ORIGINATION FORM

Proposed Revisions to a Standard Plans Index
(Please provide all information — Incomplete forms will be returned)

Index Number: 455-154

Index Title: 54" Precast/Post-Tensioned CFRP & SS Concrete
Cylinder Pile +

54" PRECAST/POST-TENSIONED CFRP & SS
CONCRETE CYLINDER PILE

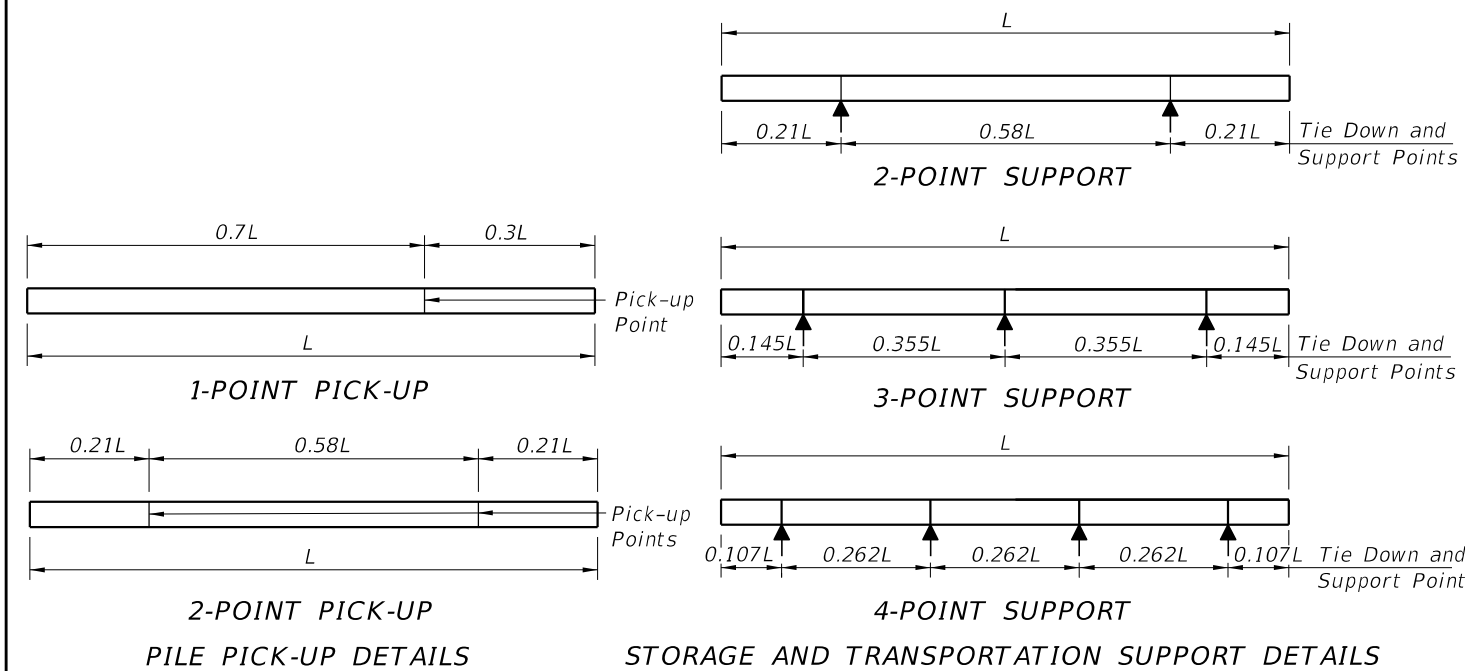
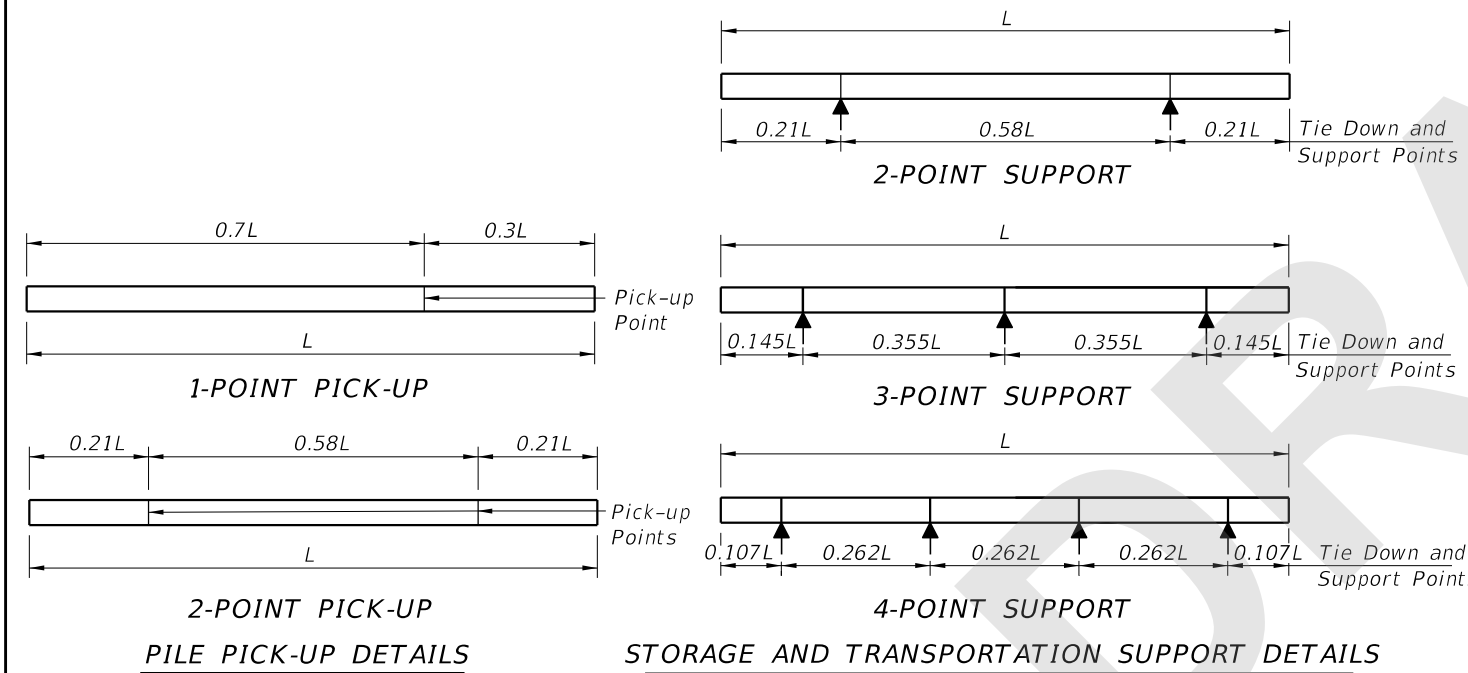
Change Silica Fume, metakaolin or ultra-fine flyash to Highly Reactive Pozzolans

- Work this Index with the Pile Data Table in the Structures Plans.
- Concrete:
 - Piles: Class V (Special)
 - Splice: Class IV
 - ~~Silica Fume: See "GENERAL NOTES" in Structures Plans for locations where the use of silica fume, metakaolin or ultra-fine flyash is required for options using stainless steel strand and reinforcing.~~ **Highly Reactive Pozzolans**

1. Work this Index with the Pile Data Table in the Structures Plans.
2. Concrete:
 - A. Piles: Class V (Special)
 - B. Splice: Class IV
 - C. See "GENERAL NOTES" in Structures Plans for locations where the use of Highly Reactive Pozzolans is required for options using stainless steel strand and reinforcing.
